ADDENDUM NO. 1

TO THE INVITATION TO BID DOCUMENTS FOR Barnett Pump Station

May 6, 2025

EXTERIOR DETAILS

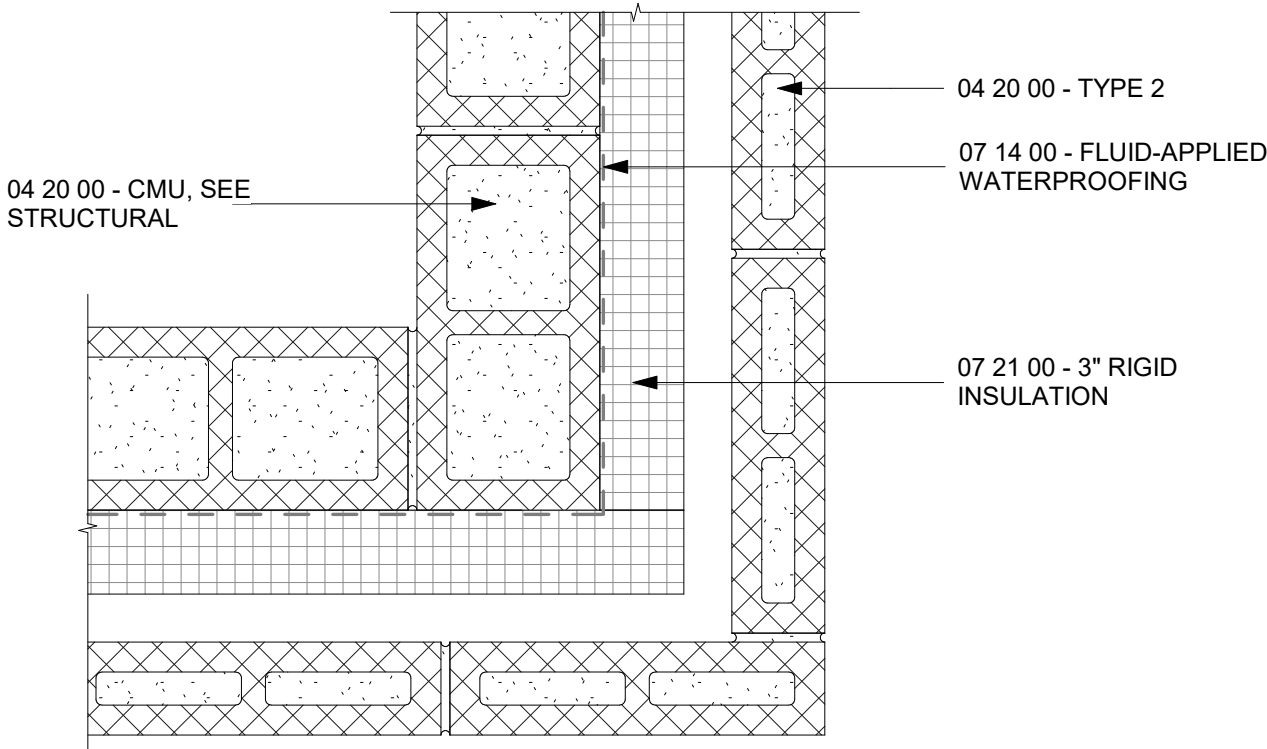
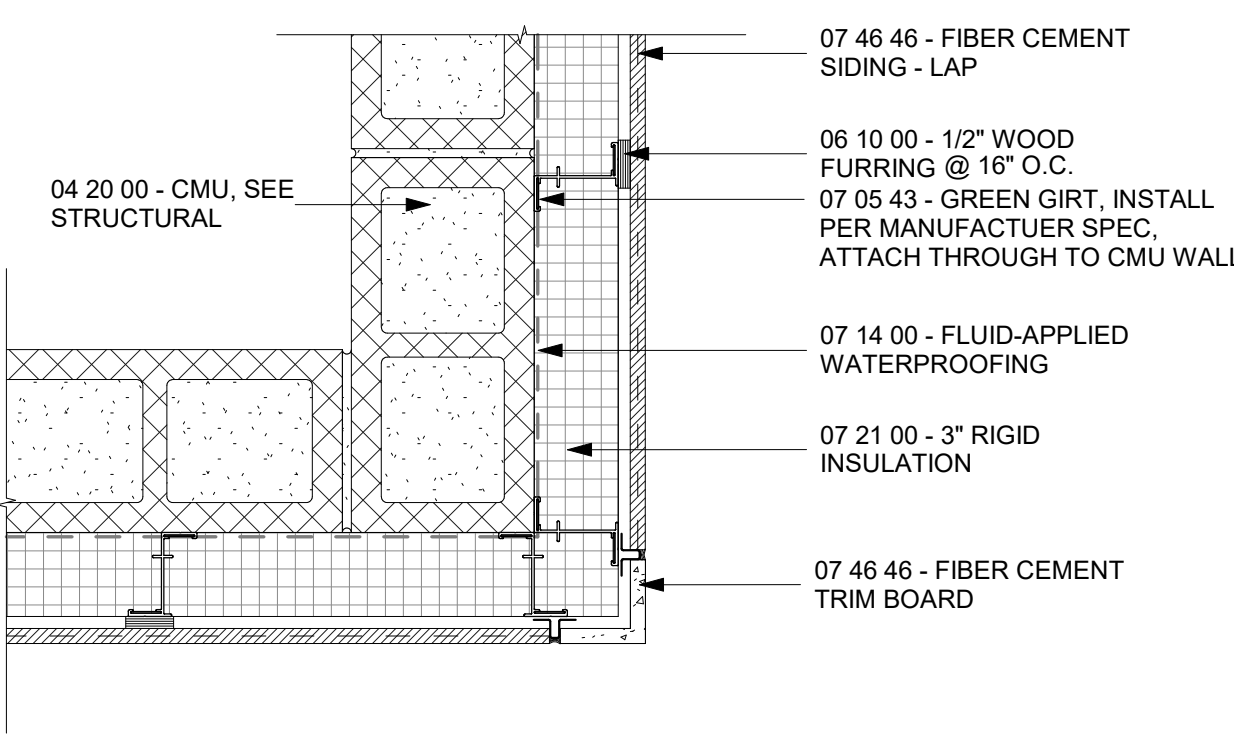
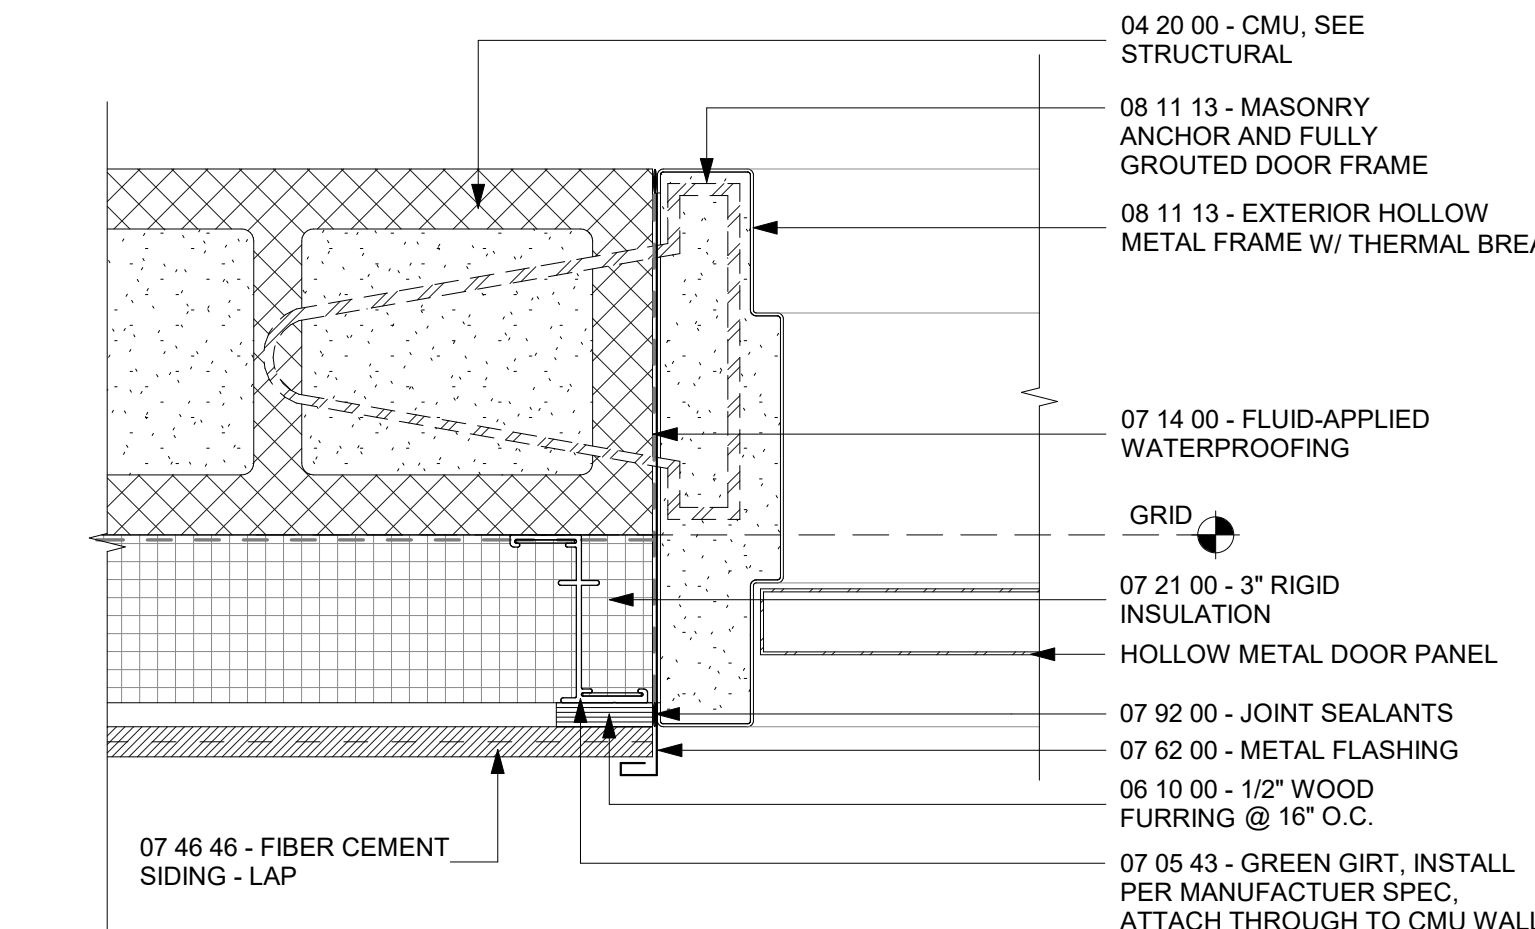
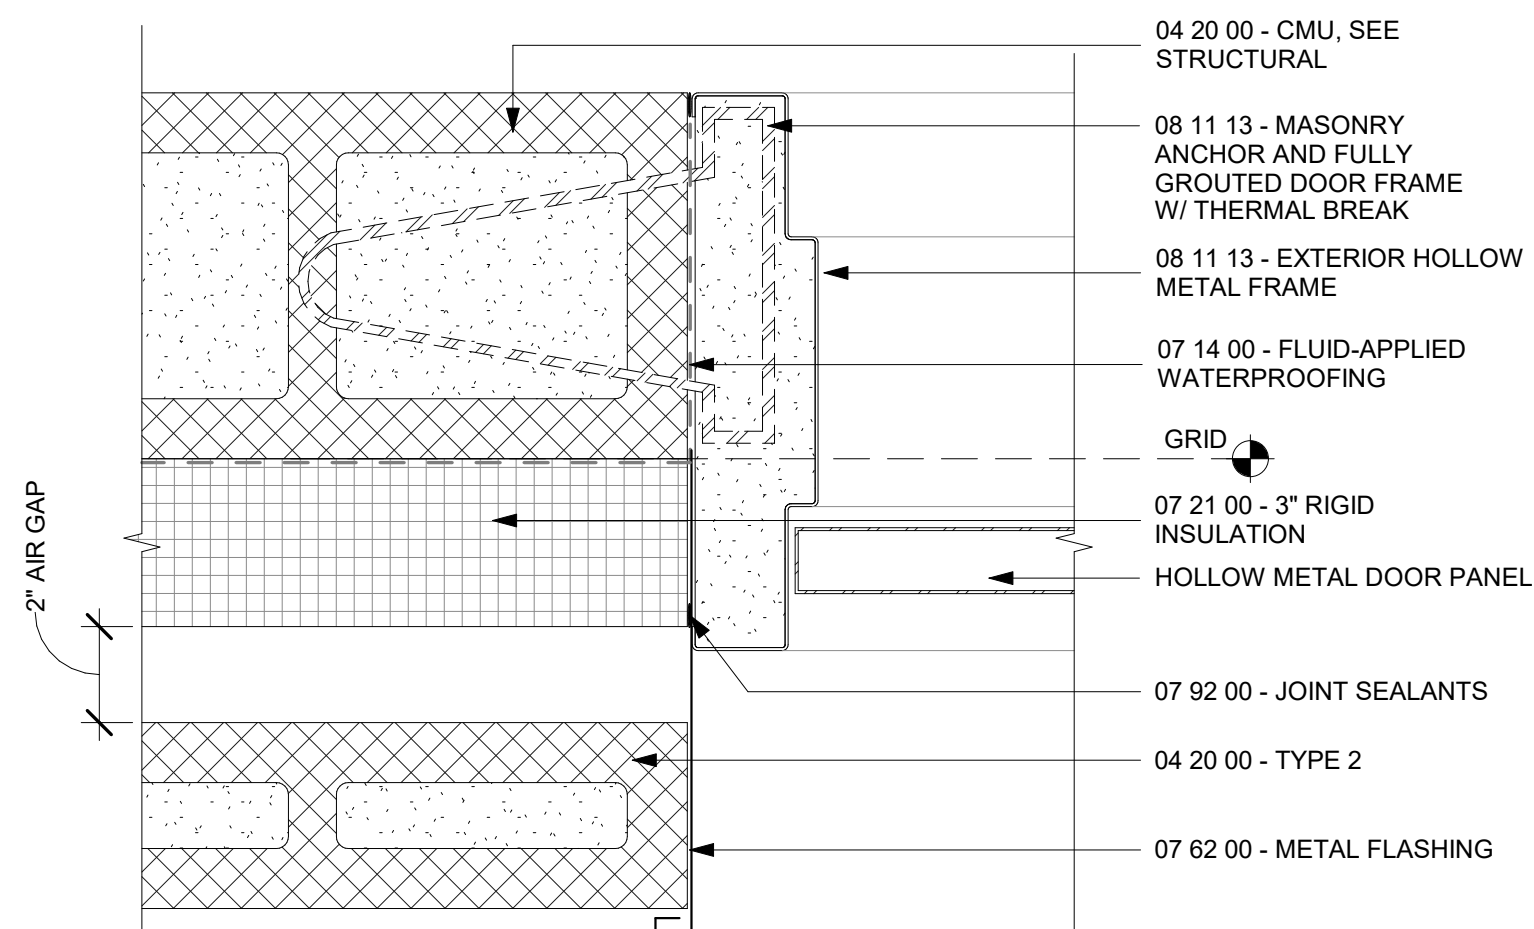
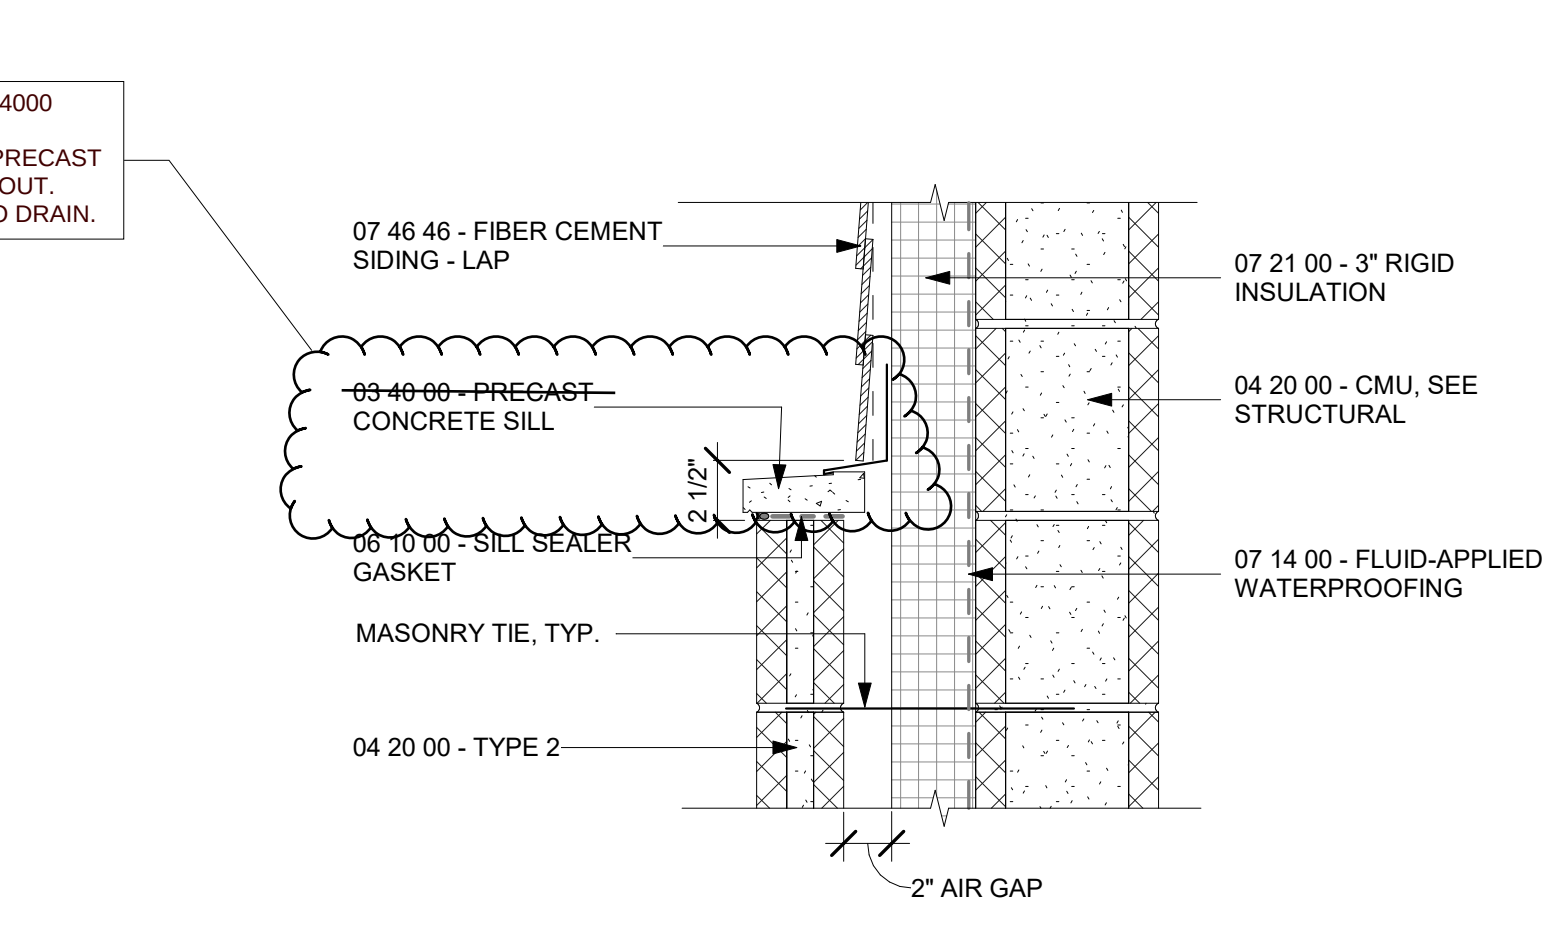
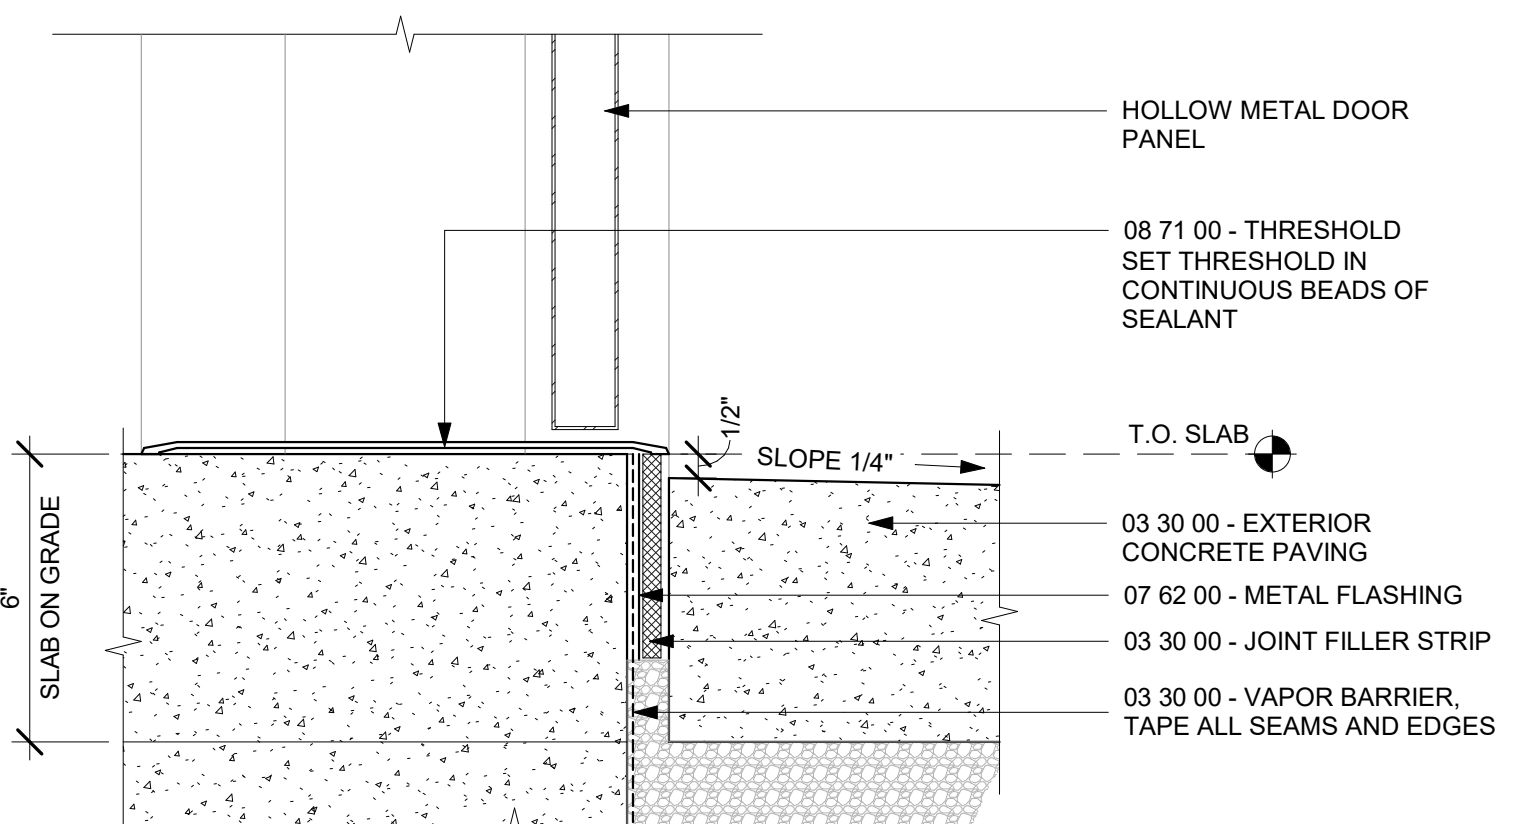
Item No.	Question	Response or Clarification
1-01	The drawings are calling for precast sill spec section 03 4000 at the top of the CMU Veneer , I am unable to locate that section, can you provide direction.	See revised sheet A12 for clarification.
1-02	Spec calls for 1/4" tempered glass. A16 calls for security glazing. Please provide further clarification on security glazing requirements, or standard safety glass will be assumed.	See revised sheet A16 for clarification.
1-03	Will any domestic material requirements be needed on this project?	Barnett Pump Station Supplementary Information, Water Facility Standards, Section IV – Standard Specifications IIA – Pipe and Fittings, B-0 Ductile Iron Pipe General, Pg. 2 of 18, paragraph 8 states “The ductile iron pipe manufacturer and supplier shall certify that pipe shipments comply with provisions of the Buy American Act as contained in the Supplemental Provisions of the specifications of the Bureau of Reclamation”. The intent is that all ductile iron pipe, fittings, and appurtenances be domestically manufactured.

1-25	S05	Replace this drawing with the revised drawing attached to this addendum. Revisions to the sheet are clouded. Addition of the pump base detail.
1-26	A12 A16	Replace this drawing with the revised drawing attached to this addendum. Revisions to the sheet are clouded. Door hardware schedule and door glass clarification have been added.
1-27	L03 L06	Replace these drawings with the revised drawings that are attached to this addendum. Revisions to these sheets are clouded. Communication Tower concrete slab removed.
1-28	M01 M02	Replace these drawings with the revised drawings that are attached to this addendum. Revisions to these sheets are clouded. Removed RFCA from piping.
1-29	P02	Replace this drawing with the revised drawing attached to this addendum. Revisions to the sheet are clouded. Removed heat trace reference.
